Access Compliance Report

Public Rights-of-Way

(Curb Ramps)

Intersection ID: 48884	Main Street: REINBECK_DR	Cross Street: OLD_POTTERS_RD	Location: S
ADA ID: 69EE3FB547B0	Ramp Type: Perp	Initial Pass/Fail: Fail	Overall Compliance: No
Severity Score: 21.25			
Codes/Mitigation Info/Possible Solution		Field Measurements/Component Compliance

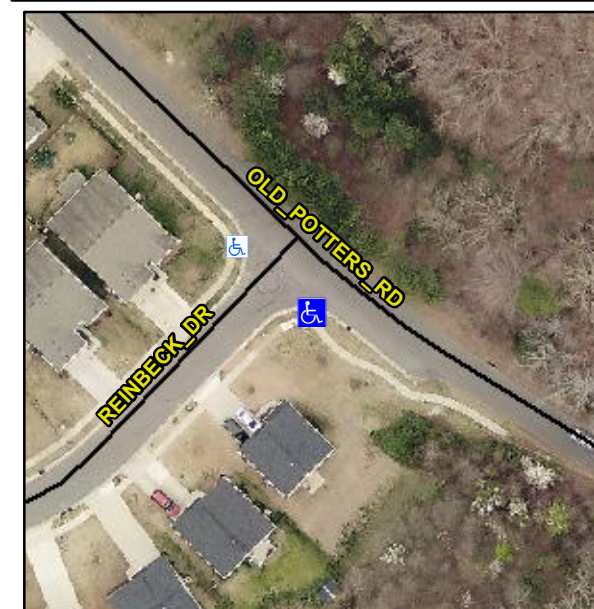
Not Found, R304.5.1, R304.5.3

Compliance	Description	Data	Compliance	Description	Data
N/A	Ramp Length (in)	45.0	Yes	Ramp Slope (%)	7.5
No	Ramp Width (in)	46.0	No	Ramp XSlope (%)	6.7
N/A	Flare Type LT	N/A	N/A	Flare Type RT	N/A
N/A	Flare Slope LT (%)	N/A	N/A	Flare Slope RT (%)	N/A
N/A	Flare Traversable LT?	N/A	N/A	Flare Traversable RT?	N/A
N/A	Landing Length (in)	N/A	N/A	DWS Provided?	N/A
N/A	Landing Width (in)	N/A	N/A	DWS Contrast?	N/A
N/A	Landing Slope (%)	N/A	N/A	DWS Length (in)	N/A
N/A	Landing X Slope (%)	N/A	N/A	DWS Full Width?	N/A
N/A	Landing Curb? (Y/N)	N/A	N/A	DWS Offset (in)	N/A
N/A	Shared Landing?	N/A			
N/A	Gutter Ponding?	N/A	N/A	Gutter Slope (%)	N/A
N/A	Gutter Lip Ht (in)	N/A	N/A	Gutter X Slope (%)	N/A
N/A	Painted X Walk1?	No	N/A	Painted X Walk2?	N/A
	X Walk 1 Direction	To NW		X Walk 2 Direction	N/A
N/A	X Walk 1 Width (in)	N/A	N/A	X Walk 2 Width (in)	N/A
	X Walk 1 Slope (%)	7.5		X Walk 2 Slope (%)	N/A
	X Walk 1 X Slope (%)	0.4		X Walk 2 X Slope (%)	N/A

Remove & Replace Entire Ramp.
